Urbicus Ref: URB24-225
Primary Contact: Mark Clayton

Applicant response to Further Issues

Council reference: DEV2024/1590
Property details: 8,12 & 16 Jamieson Street, Bowen Hills

Figure 1 – dead space areas for additional activation

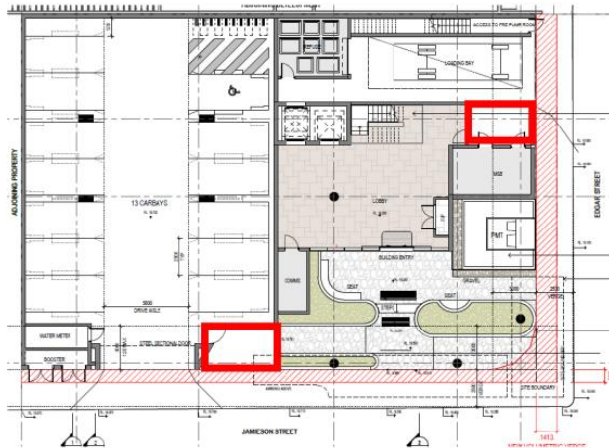
- d) Redesign the streetscape and entrance to the building to replace the steps with ramp towards the main entrance and replace the ramp with the stairs.
- e) Extend Edgar Street lobby rather than having the extra loading area space that is unused and highlighted in red below on Figure 1. This is to provide an improved street interface and activation response or an alternative design may be considered.
- f) Sleeve the car parking on Jamieson Street with landscaping or lobby space as illustrated in Figure 1 below.

The following changes have been made to the architectural plans:

- Steps have been removed and replaced with a ramp towards the main entrance.
- The MSB and PMT have shifted west by 700mm and the lobby extended east by 500mm. This improves the visibility of the lobby to both Jamieson and Edgar Streets. This is considered a superior outcome, to that suggested by EDQ, noting Edgar Street is a secondary frontage.

Refer to Drawing DA01 prepared by Nettletontribe.
